Project	IEEE 802.16 Broadband Wireless Access Working Group < http://ieee802.org/16 >
Title	Details of SDD Section 11.9.2.1 Uplink Fast Feedback Channel
Date Submitted	2008-09-05
Source(s)	Fan Wang, Weimin Xiao, Bishwarup Mondal, Amitava Ghosh, Mark Cudak, Fred Vook Motorola E-mail: fanw@motorola.com
Re:	SDD Session 56 Cleanup, Call for PHY Details
Abstract	This is revised version of Section 11.6 of IEEE 802.16m-08/003r4. This document provides further physical layer details.
Purpose	Draft for further development of the IEEE 802.16m SDD
Notice	<i>This document does not represent the agreed views of the IEEE 802.16 Working Group or any of its subgroups. It represents only the views of the participants listed in the "Source(s)" field above. It is offered as a basis for discussion. It is not binding on the contributor(s), who reserve(s) the right to add, amend or withdraw material contained herein.</i>

Details of SDD Section 11.9.2.1 Uplink Fast Feedback Channel

11.9.2.1 UL Fast Feedback Channel

Figure 1. UL Fast Feedback Channel Timing Diagram (example)

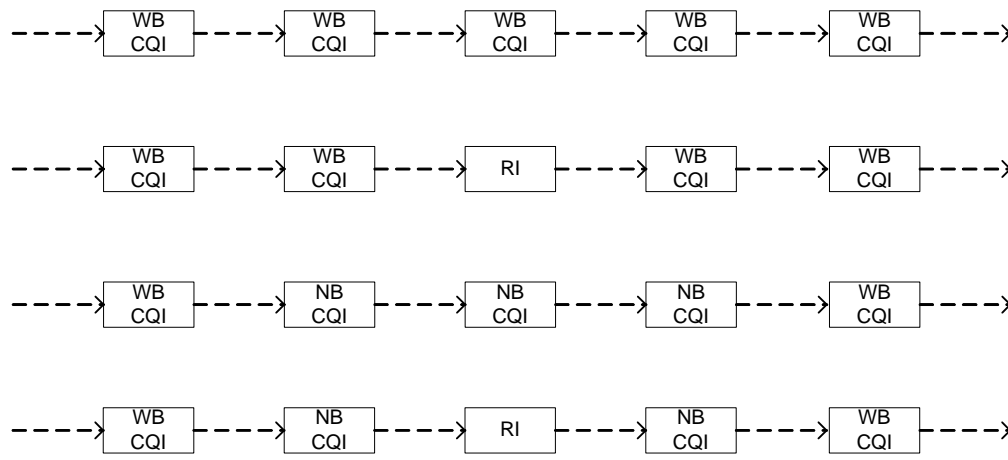
The UL fast feedback channel starts at a pre-determined location, with the size defined in a DL broadcast control message. Fast feedback allocations to an MS can be periodic and the allocations are configurable. For periodic allocations, the specific type of feedback information carried on each fast feedback opportunity can be different. Wideband fast feedback information, narrow band fast feedback information, and rank indication for MIMO feedback can be feedback with different time period (Figure 1). Further, one feedback channel may contain wideband CQI information, narrow band CQI information, PMI, rank indication or a mixture of them.

For Event driven feedback information, they are transmitted through UL inband control channel following the allocation message from the BS.

- Deleted:** Transmission of other feedback information on the UL fast feedback channel is FFS.¶
- Deleted:** The UL fast feedback channel is classified into multiple logical channels per user.
- Deleted:** these logical channels
- Deleted:** one or multiple
- Deleted:** FFS

Figure 2. UL Fast Feedback Channel Pilot and Data Tone allocations

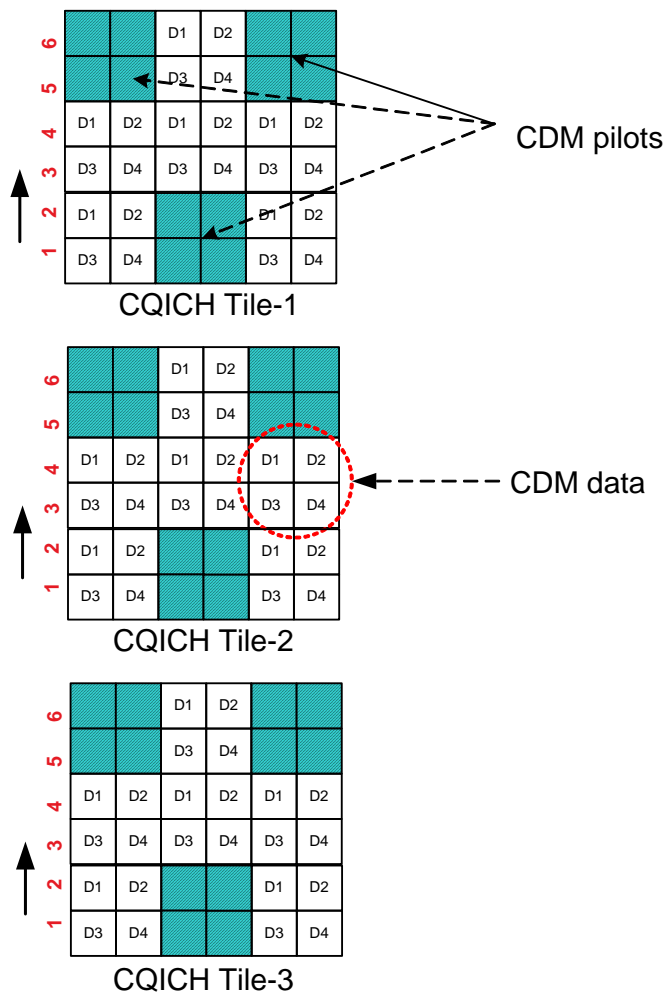
Periodic fast feedback information that is transmitted on UL fast feedback channel is QPSK modulated with coding rates depending on number of information bits in the CQI feedback. Further, transmit power of fast feedback channel is adaptively adjusted to the channel fading according to UL power control.

Deleted: The structure of the resource blocks, pilots and resource mapping for the UL fast feedback channel are TBD

Four UL fast feedback channels are multiplexed together using a mixture of FDM/TDM/CDM in three UL DRU tiles. For each group of four tones that are adjacent in time and frequency, pilot and data symbols from four fast feedback channels are CDMed together in order to take full advantage of the MS transmit power. Further, since these four tones are adjacent in time and frequency, orthogonal codes can be used to separate the four fast feedback channels. Finally, multiple groups of four tones are allocated in each tile with FDM/TDM. The pilot and data tone allocations are shown in Figure 2.

Figure 3. UL Fast Feedback Channel Pilot and Data Tone allocations

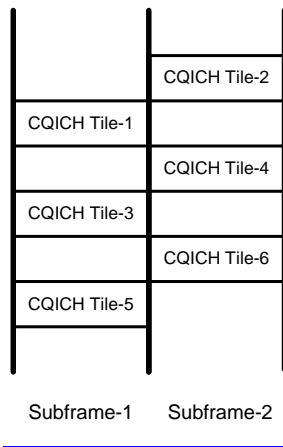
In order to improve the coverage of fast feedback channel for cell edge MSs, the UL fast feedback tiles are allocated in time dimension first as shown in Figure 3. Further, subframe based frequency hopping of the tiles can be applied to improve the frequency diversity.
